AIR RESOURCES BOARD

Executive Order G-70-25-C

Relating to the Modification of the Certification of the
Atlantic Richfield Balance
Phase II Vapor Recovery System

EXECUTIVE ORDER G-70-25-C
ATLANTIC RICHFIELD COMPANY BALANCE PHASE II
VAPOR RECOVERY SYSTEM

EXHIBIT 1

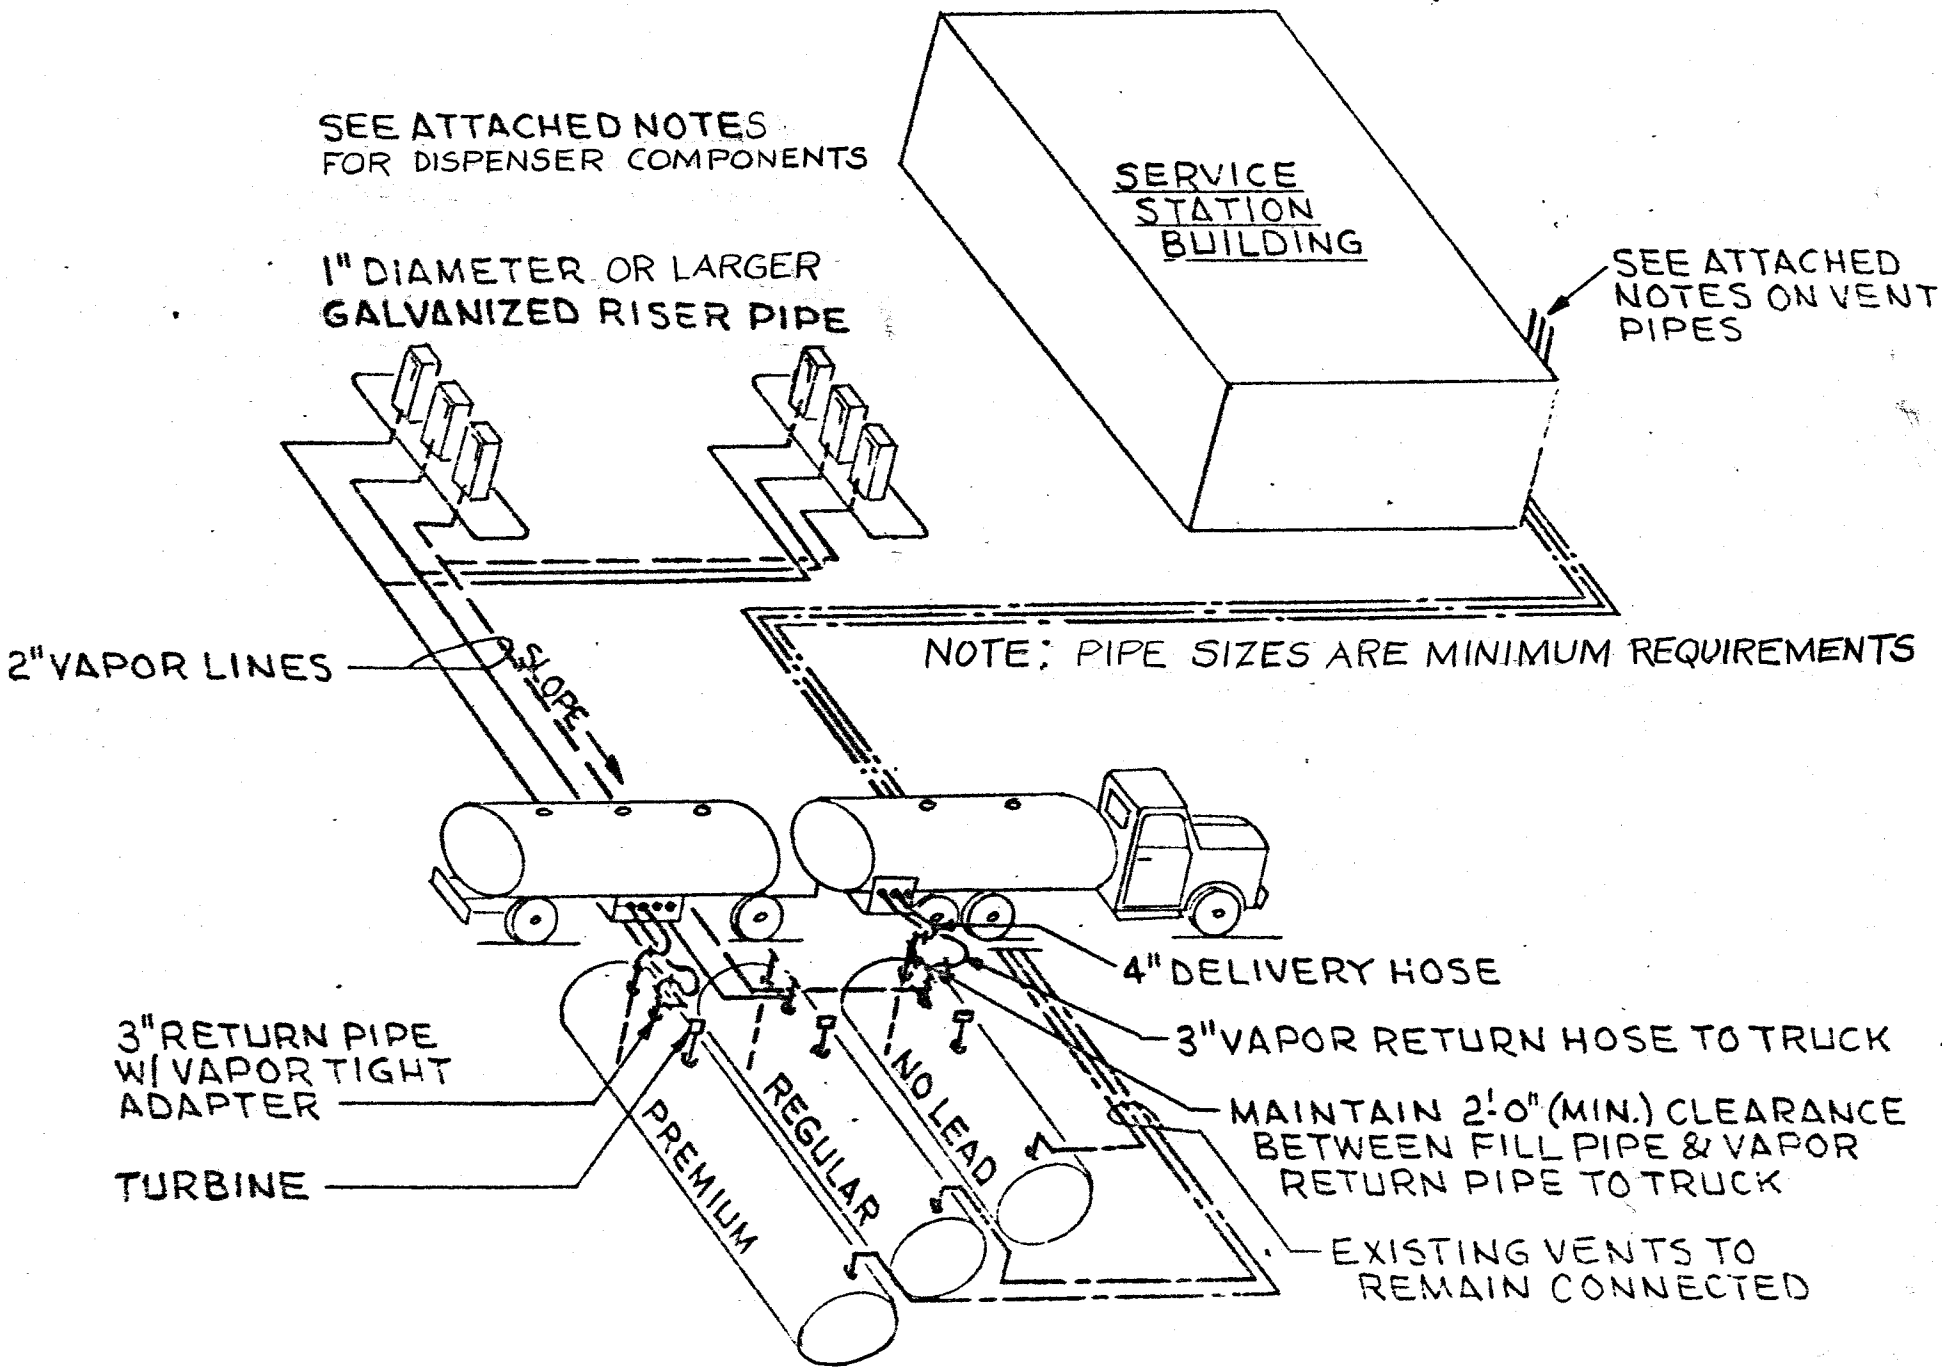
IT IS ORDERED AND RESOLVED: That the certification Executive Order G-70-25-B issued on August 3, 1979 for the Atlantic Richfield balance Phase II vapor collection and disposal system is hereby modified to include OPW-7VC nozzles as alternate nozzles. The system hereby modified is certified to be at least 95% effective in self-serve and/or attendant use at gasoline service stations in conjunction with Phase I vapor recovery systems which have been certified by the Air Resources Board. The system is described in Exhibits 1 and 2, attached hereto.
